AIA Document G701® – 2017

Change Order

PROJECT: <i>(Name and address)</i> 22210000 Linn-Mar Administration Building 3556 Winslow Road Marion, IA 52302	CONTRACT INFORMATION: Contract For: New Linn-Mar Administration Building Date: June 5, 2023	CHANGE ORDER INFORMATION: Change Order Number: 006 Date: March 8, 2024
OWNER: <i>(Name and address)</i> Linn-Mar Community School District 2999 North Tenth Street Marion, IA 52302	ARCHITECT: <i>(Name and address)</i> OPN Architects 200 5th Ave. SE, Suite 201 Cedar Rapids, IA 52401	CONTRACTOR: <i>(Name and address)</i> Peak Construction Group 660 Liberty Way, Unit C North Liberty, IA 52317

INSTRUCTION TO CONTRACTOR – ITC NO. 013R

1 TECHNOLOGY PLAN
1/8" = 1'-0"

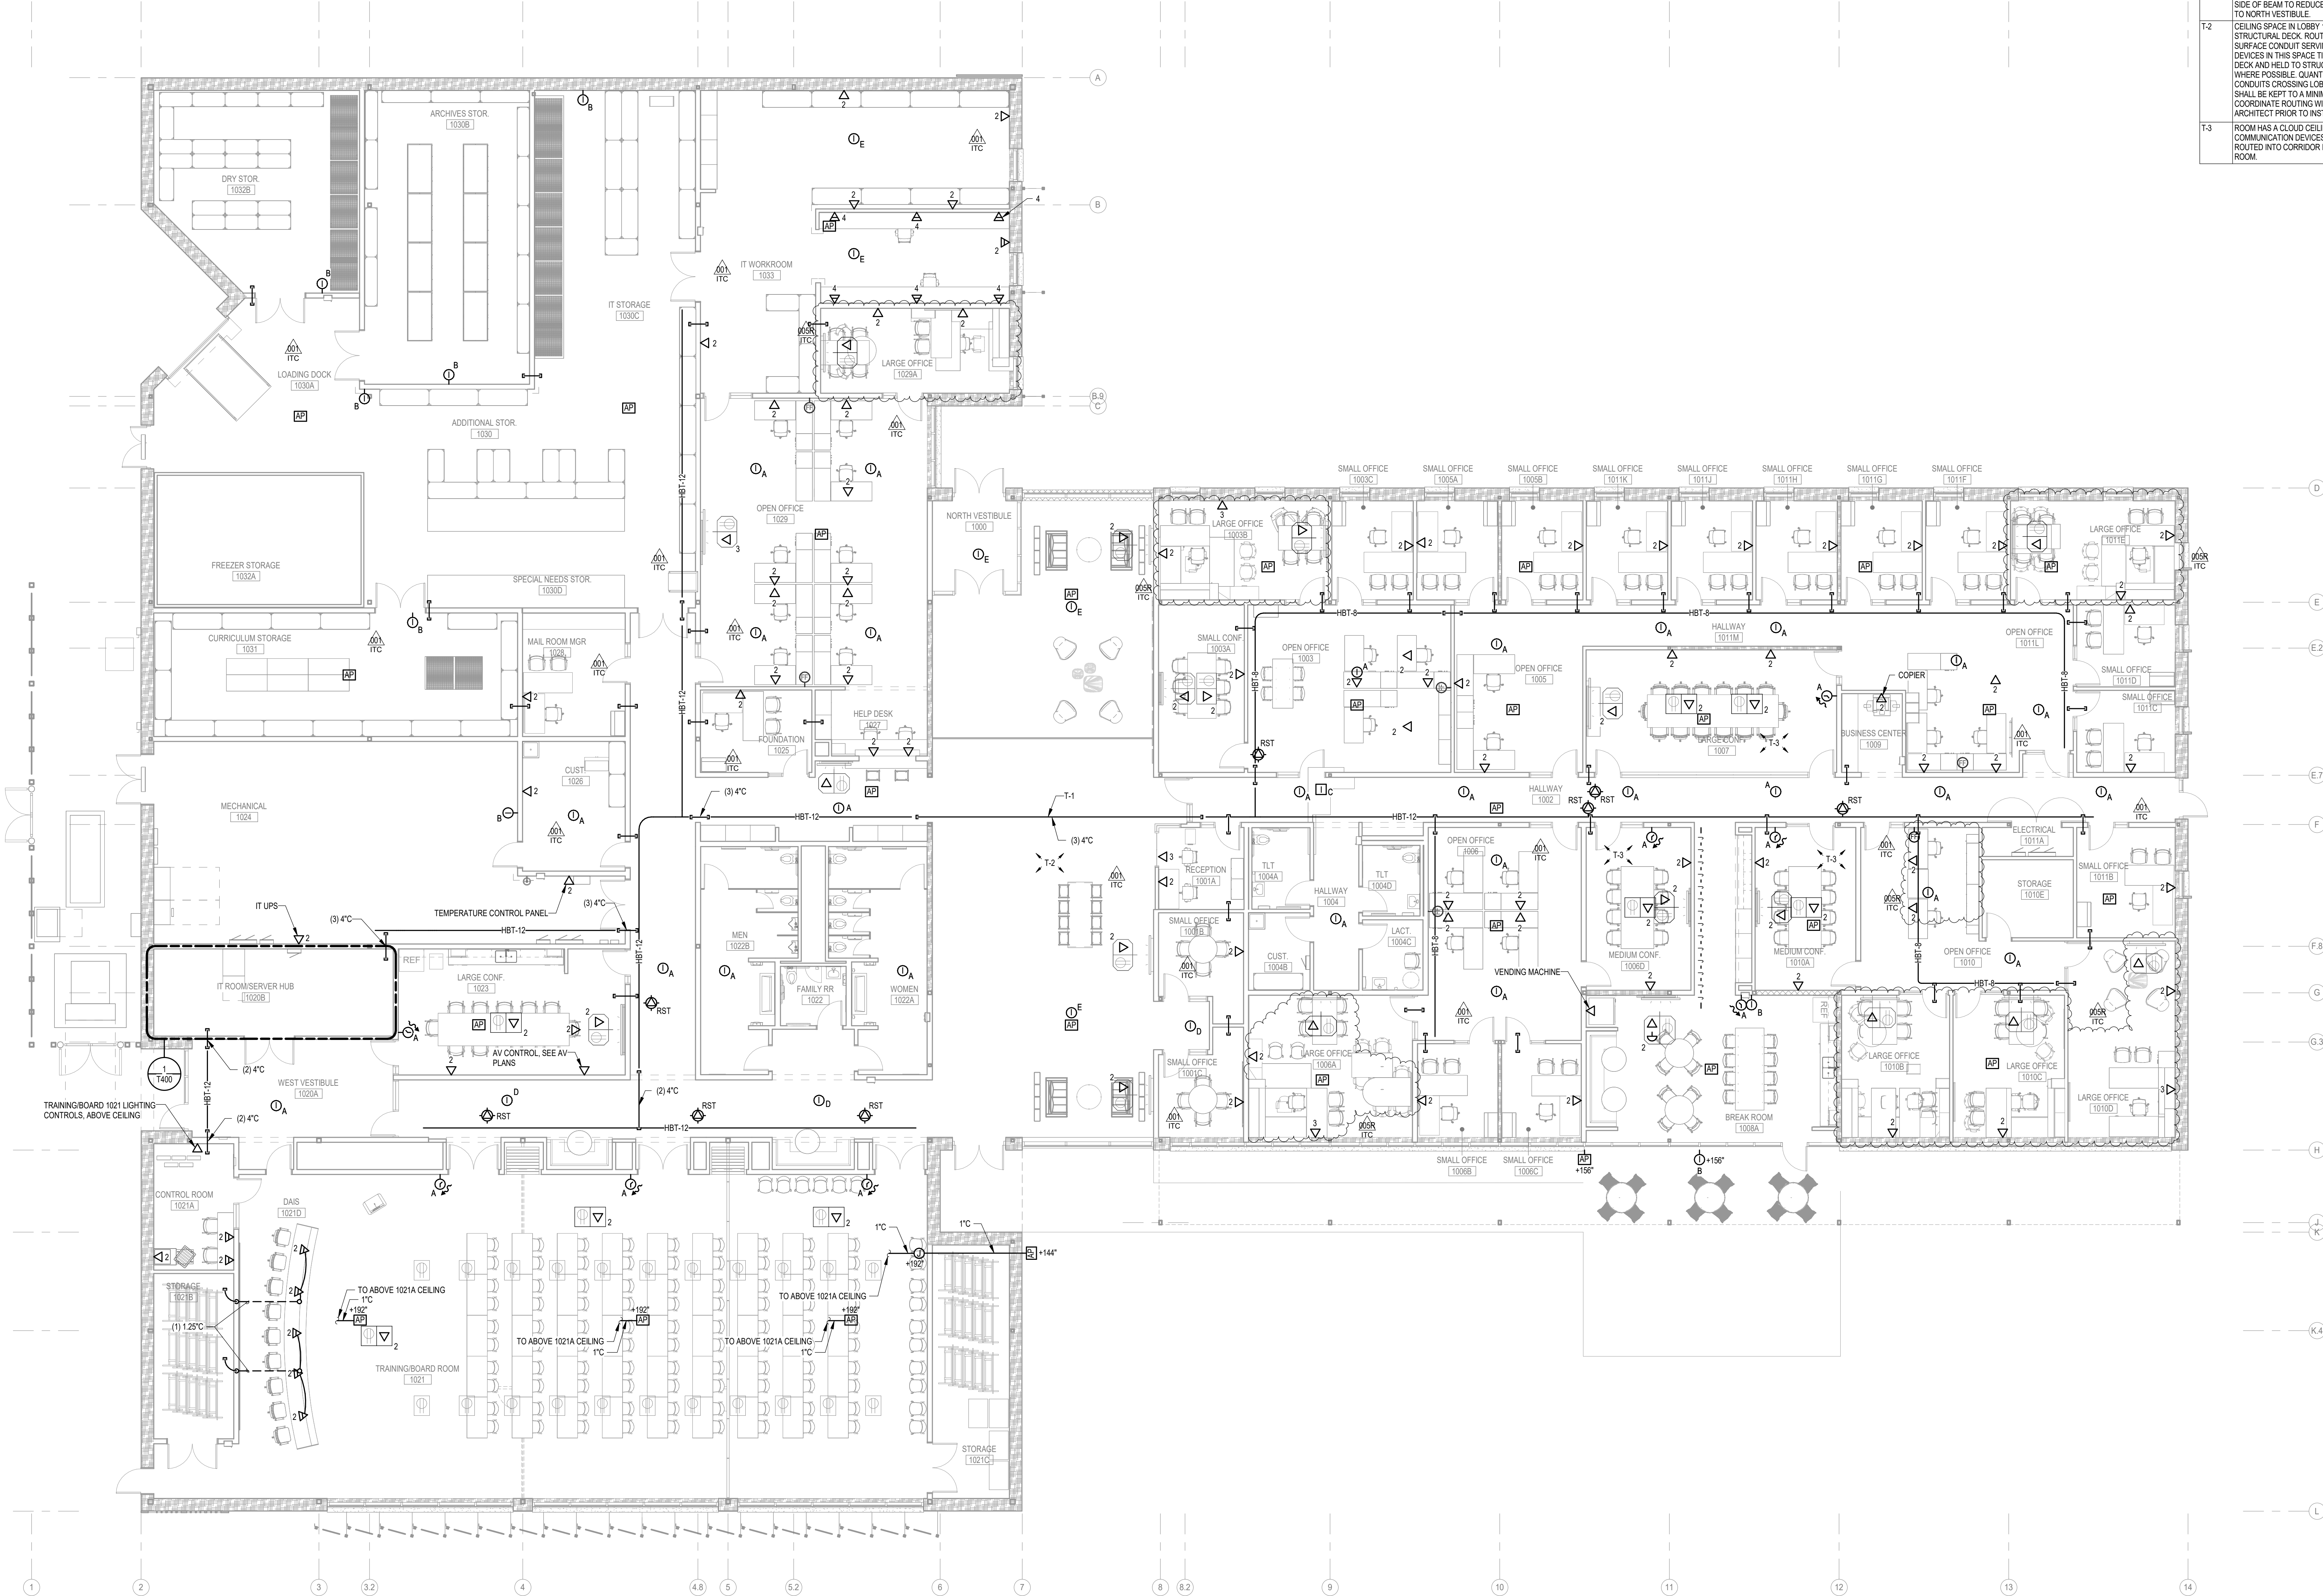
- 3. REVISE the double duplex receptacle on the plan south wall to be a single duplex.
2. T111: TECHNOLOGY PLAN – Refer to Reissued Sheet.
- i. Large Office 1003B:

- 1. REVISE location of wall activation box data on the plan east wall further plan north to align with revised activation box location.
 - 2. REVISE the two data drops shown on the plan south wall to instead be on the plan west wall adjacent to the duplex receptacle being revised to a double duplex receptacle.

- ii. Large Office 1006A:
 - 1. REVISE location of wall activation box data to the plan north wall to align with revised activation box location.
 - 2. REVISE the two data drops shown on the plan north wall to instead be on the plan south wall adjacent to the duplex receptacle being revised to a double duplex receptacle. REVISE quantity of drops to three (3) in lieu of two (2).

- 3. REVISE the three data drops shown on the plan west wall to quantity two (2) drops.
 - iii. Large Office 1010:
 - 1. ADD a furniture feed data connection on the plan north wall, adjacent to the door sidelight. For clarification, the quantity four data drops in Open Office 1010 shall be routed through the furniture feed in lieu of directly terminated at the wall. Refer to the updated furniture plan.

- iv. Large Office 1010B:
 - 1. REVISE location of wall activation box data to the plan north wall to align with revised activation box location.
 - 2. REVISE the two data drops shown on the plan west wall to instead be on the plan south wall adjacent to the duplex receptacle being revised to a double duplex receptacle.

- v. Large Office 1010C:
 - 1. REVISE location of wall activation box data to the plan north wall to align with revised activation box location.
 - 2. REVISE the two data drops shown on the plan east wall to instead be on the plan south wall adjacent to the duplex receptacle being revised to a double duplex receptacle.

- vi. Large Office 1010D:
 - 1. REVISE location of wall activation box data to the plan north wall to align with revised activation box location.
 - 2. REVISE the three data drops shown on plan north side of the plan east wall to instead be two (2) data drops.

- 3. REVISE the two data drops shown on the plan south side of the plan east wall to instead be quantity three (3) drops.
 - vii. Large Office 1011E:
 - 1. REVISE location of wall activation box data on the plan west wall further plan north to align with revised activation box location.

- 2. REVISE the three data drops shown on the plan south wall to instead be two (2) data drops.
 - 3. REVISE the two data drops shown on the plan north wall to instead be quantity three (3) drops on the plan east wall adjacent to the duplex receptacle being revised to a double duplex receptacle.

- viii. Large Office 1029A:
 - 1. REVISE location of wall activation box data to the plan west wall in lieu of plan north wall to align with revised activation box location.

- 2. REVISE the two data drops shown on the plan south wall to instead be on the plan north wall adjacent to the duplex receptacle being revised to a double duplex receptacle.
